Re: WBI Energy Transmission, Inc.  
Wahpeton Expansion Project  
Docket No. CP22-466-000  
Supplemental Filing

Supplemental Response to FERC's August 10, 2022 Environmental Information Request

Supplemental Response to FERC’s April 4, 2022 Comments on Draft Resource Reports 1 through 8 and 10

**Figure 1 (Wild Rice River Route Alternative MP 55)**

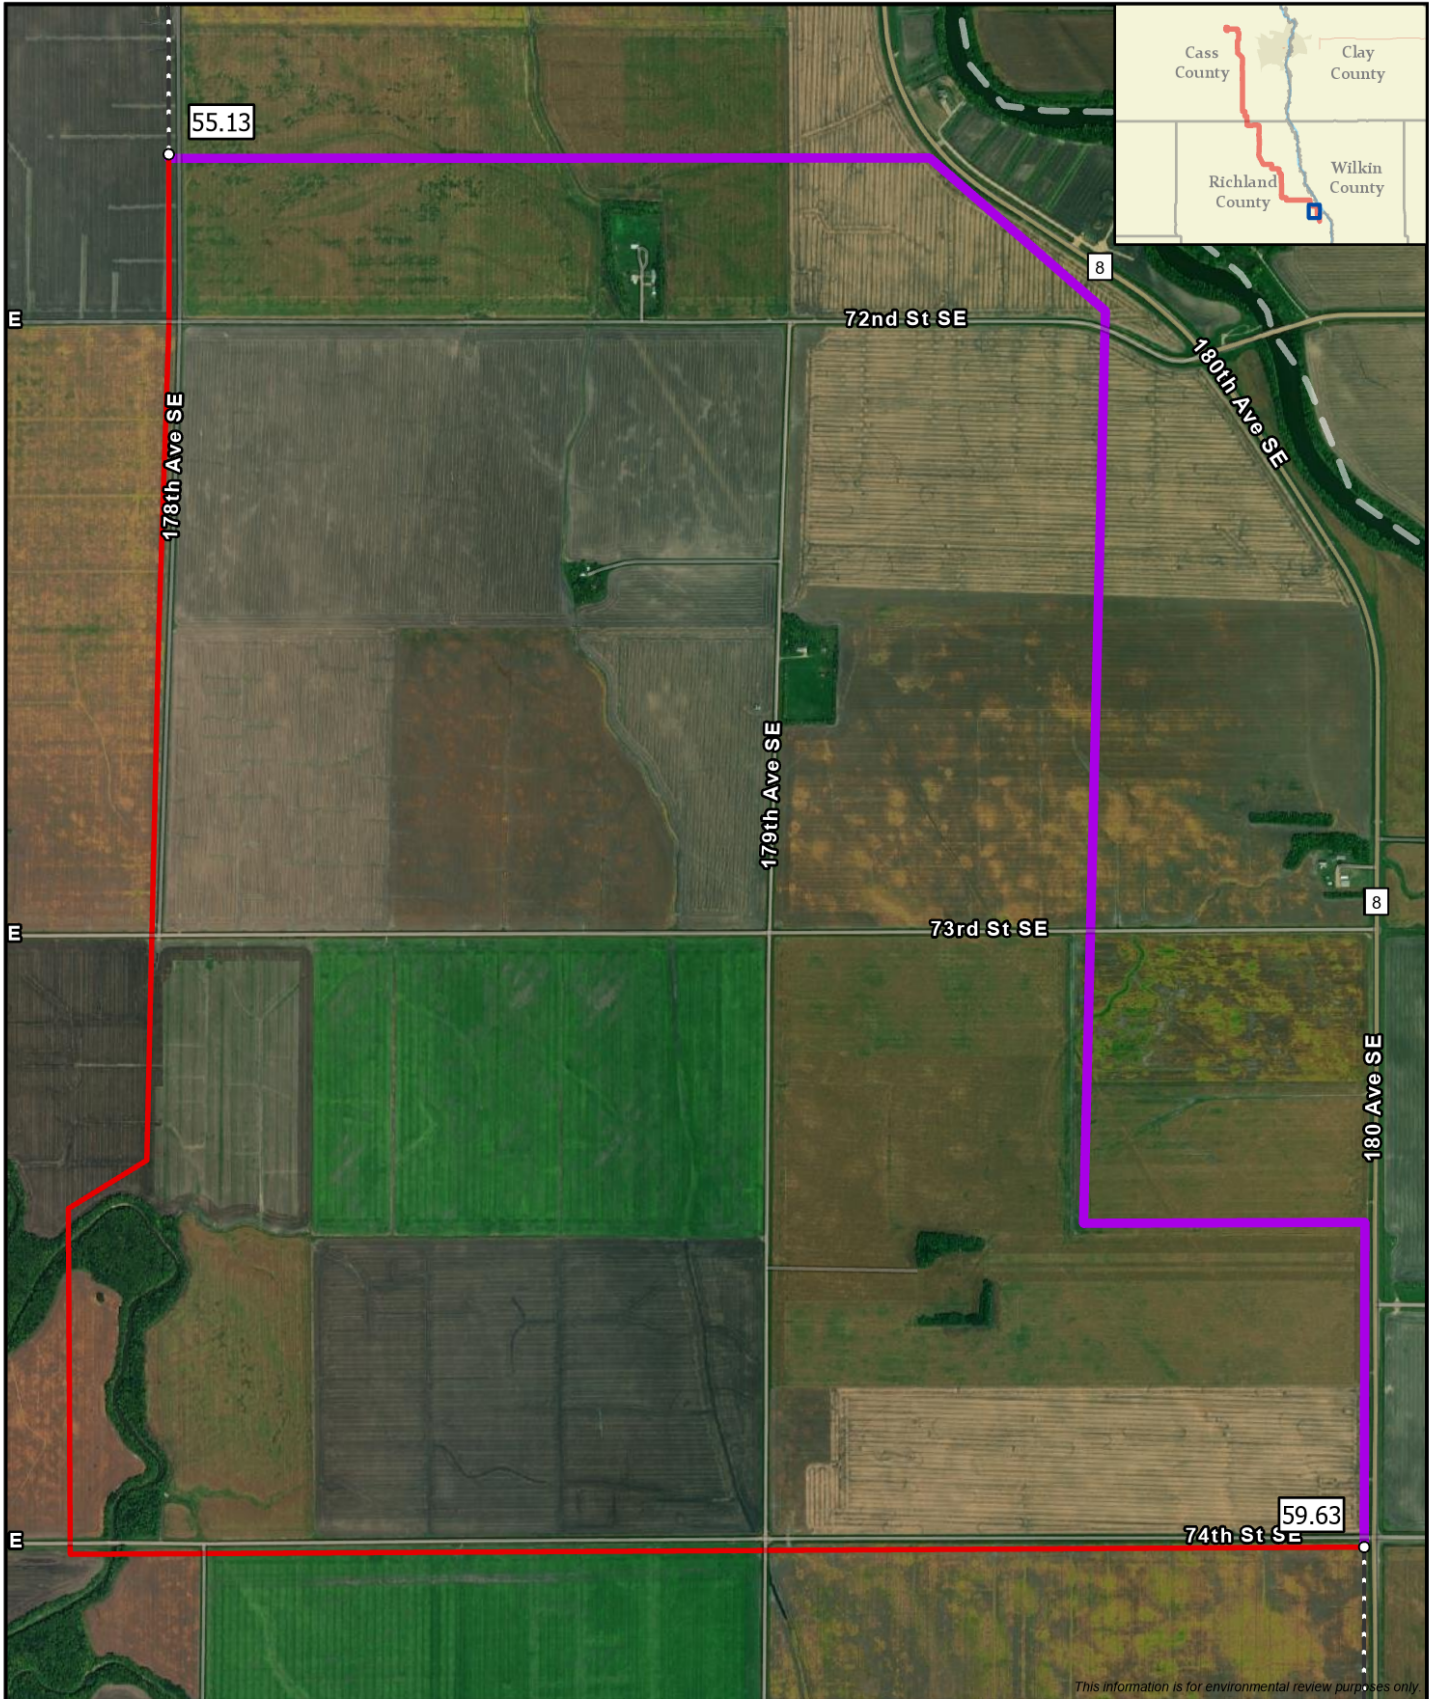
Discuss a minor variation that would shift the planned route slightly east near MP 56.8, thereby avoiding two crossings of the Wild Rice River.

In response to FERC’s request above, WBI Energy included in Resource Report 10 of its application filed with the Commission on May 27, 2022 a route variation between MPs 56.78 and 57.79 in Richland County that would avoid the two crossings of the Wild Rice River (Wild Rice River Route Variation/MP57). Upon completion of 2022 field surveys, WBI Energy has identified an additional route alternative between MPs 55.13 and 59.63 that also avoids two crossings of the Wild Rice River. This alternative is shown on figure 1 and is referred to in this analysis as the Wild Rice River Route Alternative MP 55. The alternative separates from the proposed route in Richland County in an agricultural field at MP 55.13 just west of 178<sup>th</sup> Avenue SE. From there, it continues east across agricultural land for approximately 1.26 miles until it reaches the west side of 180 Avenue SE. It then follows the west side of 180<sup>th</sup> Avenue SE on the edge of an agricultural field for 0.4 mile. After that, it turns south and eventually east crossing agricultural fields for approximately 1.96 miles until it again reaches 180 Avenue SE. From there, it proceeds south for 0.5 mile until it rejoins the proposed route on the west side of 180<sup>th</sup> Avenue SE at MP 59.63.

Resource Report 10 Request No. 5 Attachment – Figure 1 (Wild Rice River Route Alternative MP 55) and the Alternative Landowner List filed under separate cover as Controlled Unclassified Information / Privileged and Confidential (CUI//PRIV).
